Access Compliance Report

Public Rights-of-Way

Intersection ID: 4128	Main Street: COLVARD_PARK_WY	Cross Street: LAMPKIN_WY	Location:	E
ADA ID: E9B2A134AA49	Ramp Type: PerpDiag	Initial Pass/Fail: Fail	Overall Compliance: No	Severity Score: 25

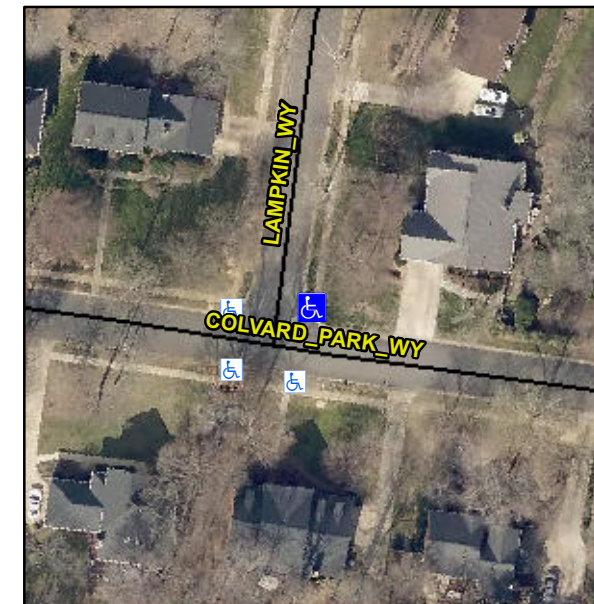
Not Found, R304.5.3

Compliance	Description	Data	Compliance	Description	Data
N/A	Ramp Length (in)	67.0	Yes	Ramp Slope (%)	5.1
Yes	Ramp Width (in)	48.0	No	Ramp XSlope (%)	9.9
N/A	Flare Type LT	N/A	N/A	Flare Type RT	N/A
N/A	Flare Slope LT (%)	N/A	N/A	Flare Slope RT (%)	N/A
N/A	Flare Traversable LT?	N/A	N/A	Flare Traversable RT?	N/A
N/A	Landing Length (in)	N/A	N/A	DWS Provided?	N/A
N/A	Landing Width (in)	N/A	N/A	DWS Contrast?	N/A
N/A	Landing Slope (%)	N/A	N/A	DWS Length (in)	N/A
N/A	Landing X Slope (%)	N/A	N/A	DWS Full Width?	N/A
N/A	Landing Curb? (Y/N)	N/A	N/A	DWS Offset (in)	N/A
N/A	Shared Landing?	N/A			
N/A	Gutter Ponding?	N/A	N/A	Gutter Slope (%)	N/A
N/A	Gutter Lip Ht (in)	N/A	N/A	Gutter X Slope (%)	N/A
N/A	Painted X Walk1?	No	N/A	Painted X Walk2?	No
	X Walk 1 Direction	To NW		X Walk 2 Direction	To SW
N/A	X Walk 1 Width (in)	N/A	N/A	X Walk 2 Width (in)	N/A
	X Walk 1 Slope (%)	5.8		X Walk 2 Slope (%)	5.0
	X Walk 1 X Slope (%)	4.3		X Walk 2 X Slope (%)	8.2

Remove & Replace Curb Ramp With Two New Directional Ramps or Equivalent.
